## AGENDA - LPP

# REPORT TO GEORGES RIVER COUNCIL LPP MEETING OF MONDAY, 07 MAY 2018

<b>LPP Report No</b>	<b>LPP012-18</b>	<b>Development Application No</b>	<b>DA2017/0218</b>
<b>Site Address &amp; Ward Locality</b>	1-3 John Street Kogarah Bay Kogarah Bay Ward		
<b>Proposed Development</b>	Demolition of existing structures and construction of seven (7) storey residential flat building containing twenty three (23) units and basement parking		
<b>Owners</b>	Development and Construction Group NSW - M Ibrahim		
<b>Applicant</b>	A Ibrahim		
<b>Planner/Architect</b>	Tecton Group Architects		
<b>Date Of Lodgement</b>	3/07/2017		
<b>Submissions</b>	Original DA - 10 submissions, amended plans - a further 3 submissions		
<b>Cost of Works</b>	\$6,243,859.00		
<b>Local Planning Panel Criteria</b>	Non compliance with KLEP 2012 and unresolved submissions		
<b>List of all relevant s.4.15 matters (formerly s79C(1)(a))</b>	Greater Metropolitan Regional Environmental Plan No 2 – Georges River Catchment, State Environmental Planning Policy (Infrastructure) 2007, State Environmental Planning Policy No 55 - Remediation of Land, State Environmental Planning Policy No 65 – Design Quality of Residential

**South western side elevation (amended plans), showing extent of non-compliance with the KLEP 2012 height control. Source: Applicant's DA plans, marked up.**

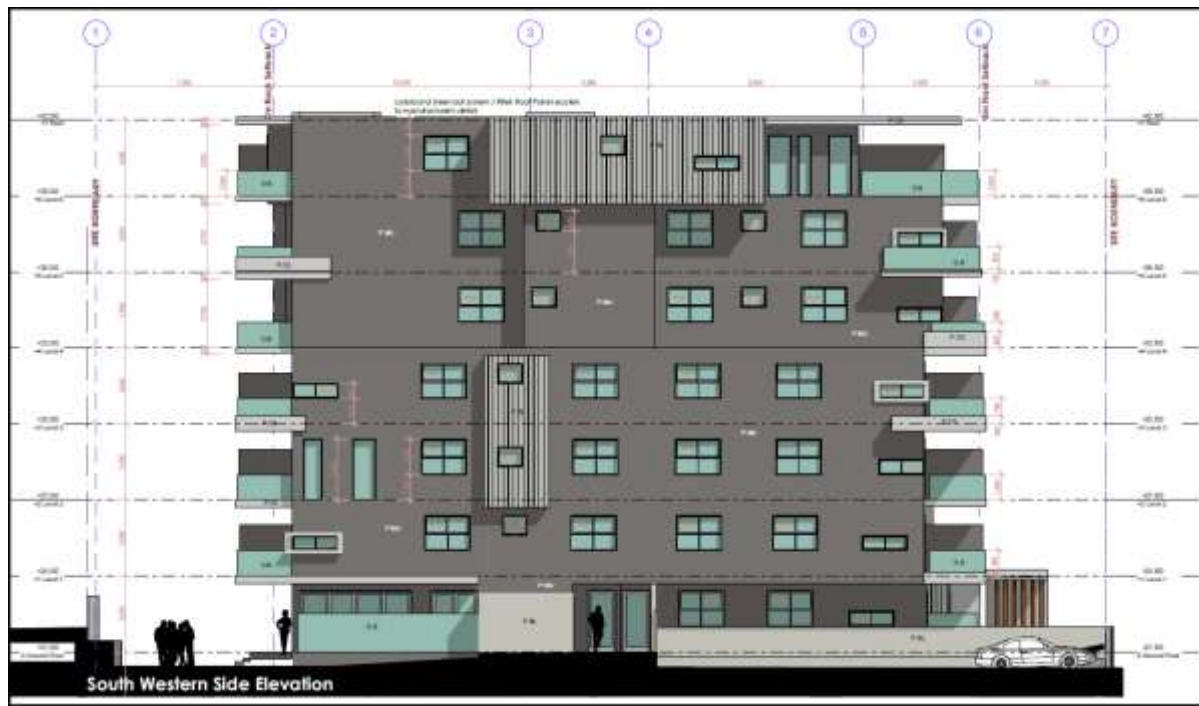
As noted above, KLEP 2012 prescribes a maximum building height of 21m. The latest amended plans for the proposed development do not comply with this requirement, as it proposes a building height of 21.71m (to the main part of the building) and 24m (to the pergola roof, the walls enclosing the rooftop communal open space, and walls of the toilet and lift/stairway core access).

It should be noted that the original DA plans also presented a non-compliance to the height control. The main reason for the greater non-compliance in the amended plans has been the provision of communal open space on the rooftop, with associated structures to provide access and amenity to that space, which was provided in amended plans as a result of the St George Design Review Panel's review of the proposal. Basically, the rooftop communal open space and associated structures have simply been placed on top of the building with minimal adjustment to the overall height of the building, which has caused the greater non-compliance to the KLEP 2012 height control in the amended plans.

Council Officers have traditionally supported minor variations to the height control for small portions of the building such as lift over-runs or the like. In this instance (as shown in the south west elevation drawing provided previously in this report) the extent of the non-compliance is not minor. For example the privacy walls and planter box enclosing the rooftop communal open space runs almost the full length of the rooftop area. Further, the stairway access to the rooftop and the bathroom have been provided with full-height walls which add to the overall height of the building.

**Streetscape Analysis drawing (view from John Street) comparing the proposed development with possible future adjoining developments. Note the 21m height limit shown, and the extent of the breach for this development. Source: Applicant's amended DA plans.**

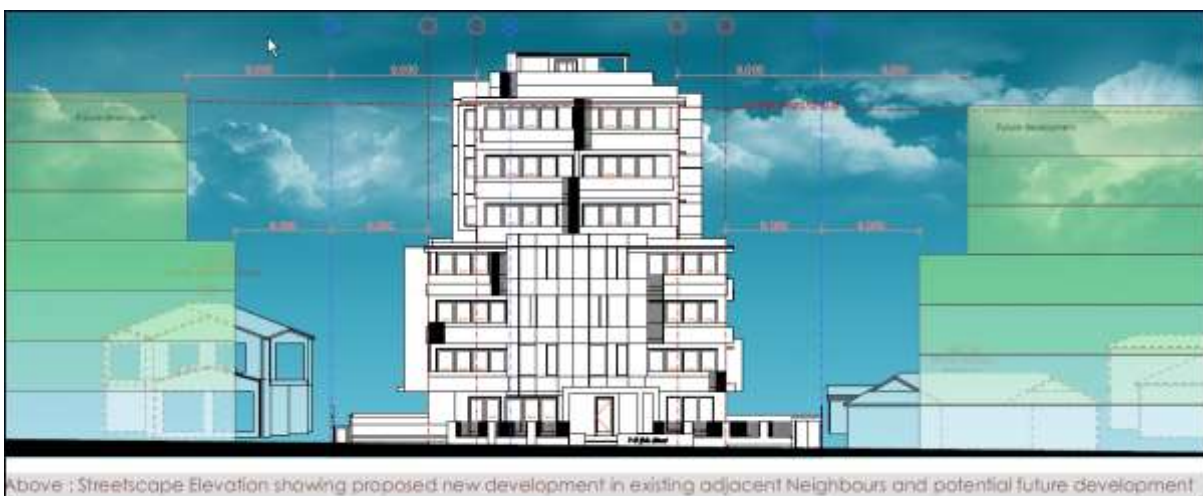
The applicant has submitted a "Streetscape Analysis" drawing which compare the proposed development with adjoining developments that could be approved under the new planning controls. This is provided below, and it shows that the development will be significantly higher than both the 21m height limit and also the desired future building heights on adjoining properties in this location:

Overall, the proposal is considered to be unacceptable in terms of its building height. The development essentially proposes an additional storey compared to the surrounding developments that have been lodged under the current planning controls, which will result in an excessive height. It will also result in unacceptable streetscape impacts as well as impacts on developments on the opposite side of John Street, because the building will have an insufficient setback at the higher levels (eg above 4 storeys) to provide a transition to the lower density zone opposite John Street.

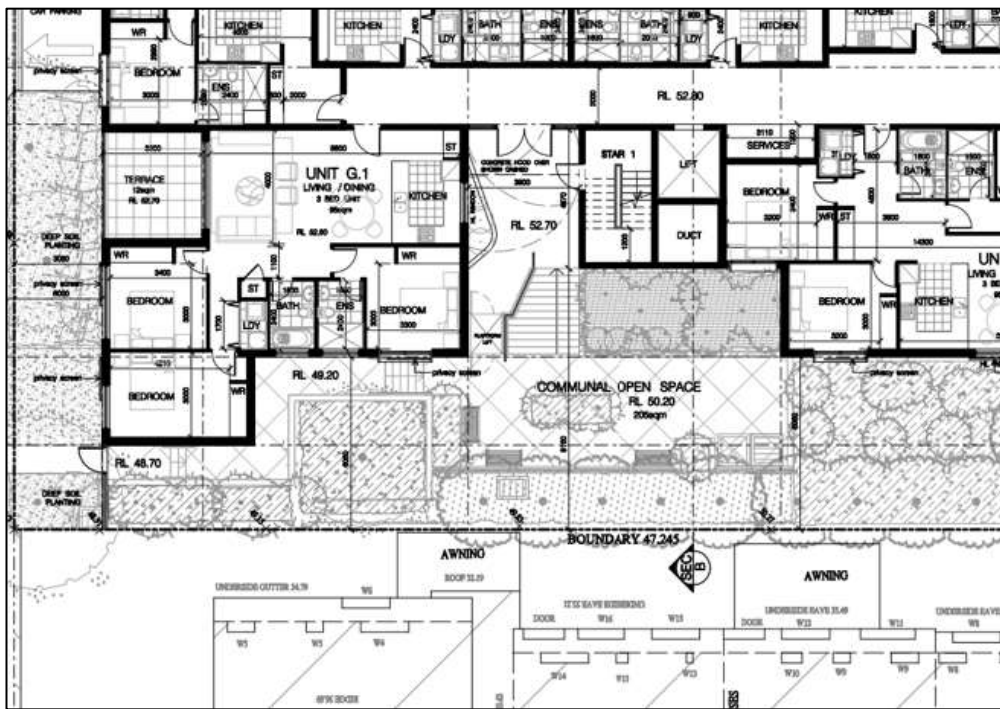
The proposed development has a site coverage of 55.8% (796sqm) in lieu of the maximum allowable 45% (641.6sqm). This non-compliance is largely the result of the DCP provisions not being reflective of the density controls permitted under the LEP. While numerically non-compliant, the proposed site coverage does not promote an overly dominant building form and will not unreasonably deny the opportunity for the provision of deep soil landscaping along the site perimeters.

The non-compliance is supported.

*Excerpt from architectural plans depicting Communal Open Space at ground level.*

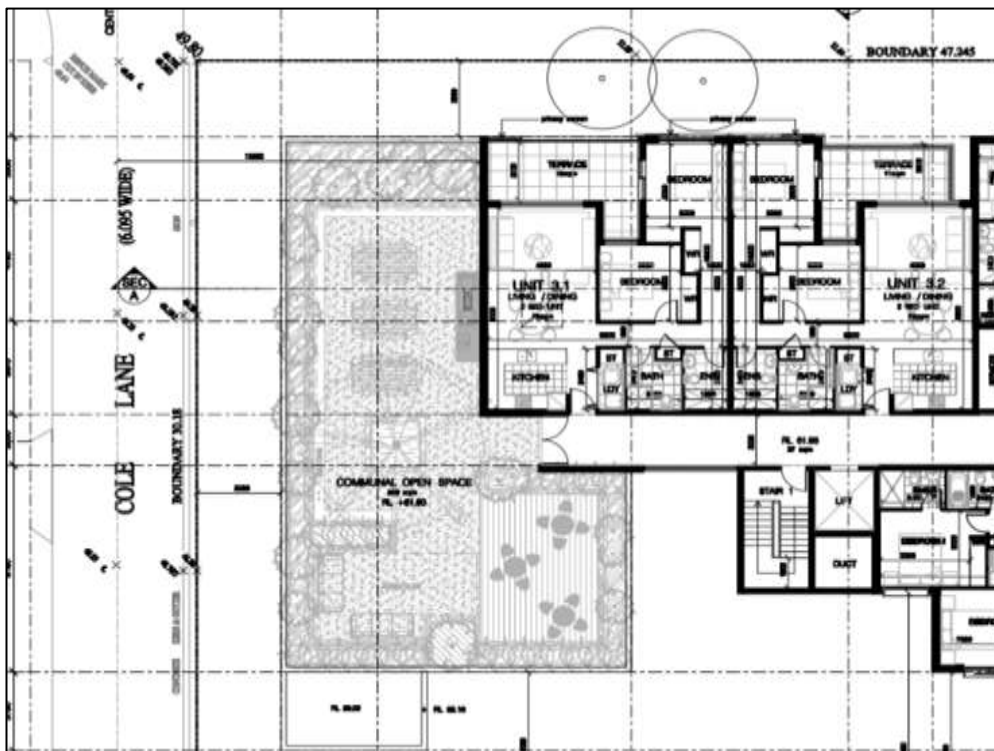
The proposal provides 28.4% or 405sqm of communal open space in two (2) separate locations on both the ground and third floor level (See excerpts below) that fails to comply with Council DCP controls of 660sqm. While failing to comply with Council's DCP provisions, the proposed areas combined exceed the minimum ADG requirements for communal open space which in this requires 356.4sqm or 25%. It is considered that as the proposed communal open space satisfies the ADG requirement and is adequate for the scale of development providing enabling opportunities for social interaction between residents.

The non-compliance is supported.

*Excerpt from shadow diagrams depicting 21 June 12:00pm proposed/existing shadow*

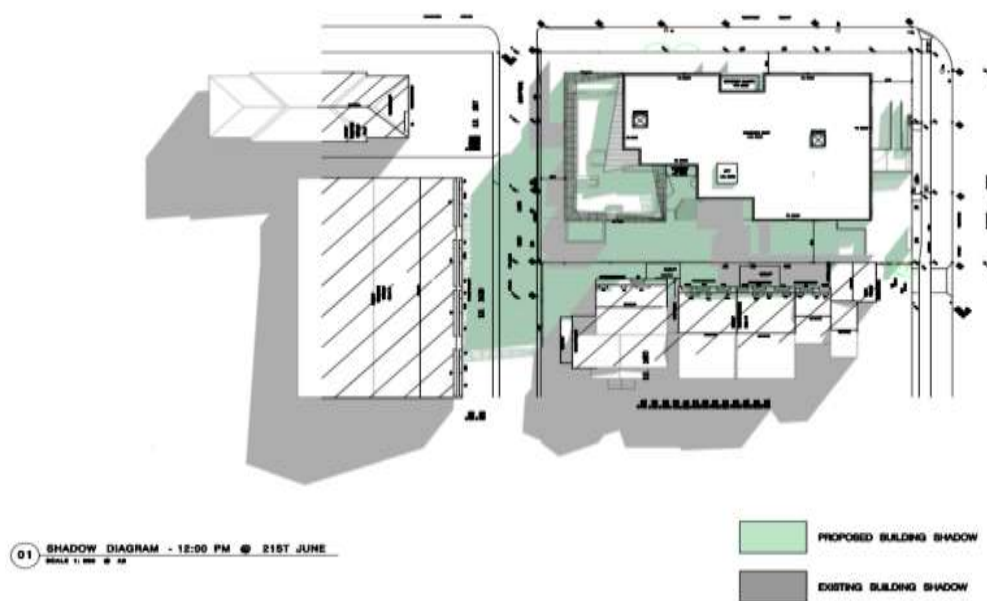
Given the orientation of the subject site to neighbouring properties and proposed development reflecting the desired future character anticipated by the height and floor space ratio specified within KLEP 2012, largely unavoidable shadowing will be cast on neighbouring developments. This impact is most notably evident upon review of the 21 June shadow diagram submitted as part of the architectural plan set which indicates a considerable amount of shadow being cast by the proposed development over the existing townhouse developments located at 25-27 Empress Street and 32-36 West Street.

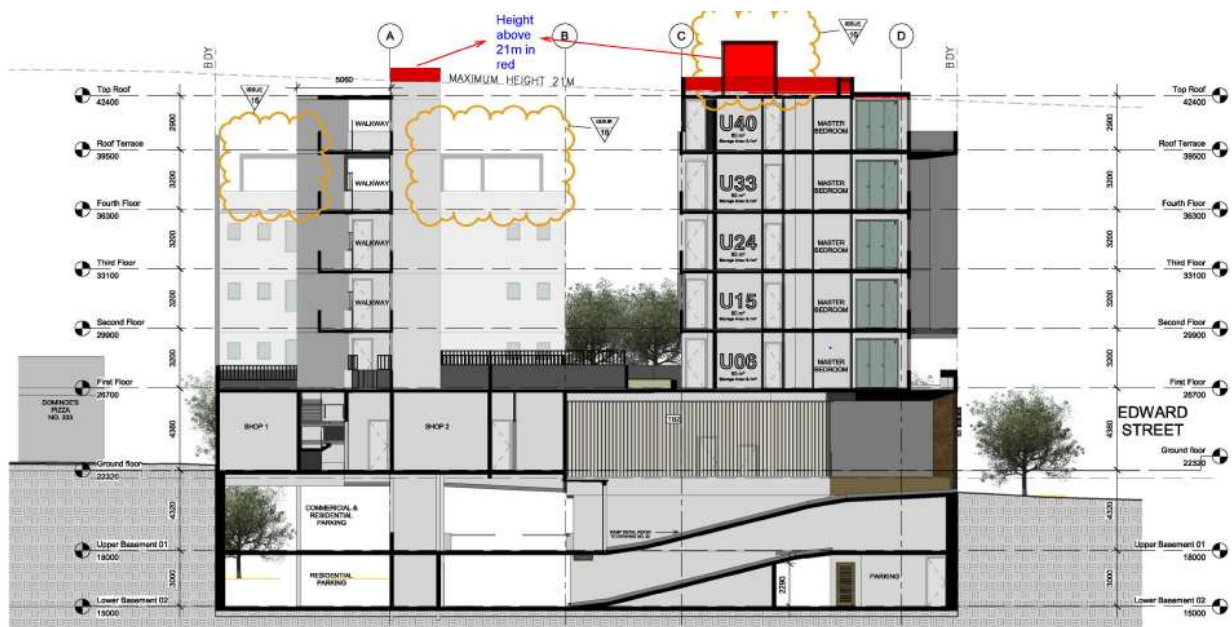
The proposed development seeks a variation to the development standard relating to height. KLEP identifies a maximum height of 21m whereas the proposed development will have a maximum height of approximately 23m for part of the development. A variation to the height can be considered under Clause 4.6 – Exceptions to Development Standards of the KLEP. In assessing the variation, the questions identified in Clause 4.6 have to be considered. The applicant's town planning consultant, Planning Ingenuity has provided a response to these questions as details below.
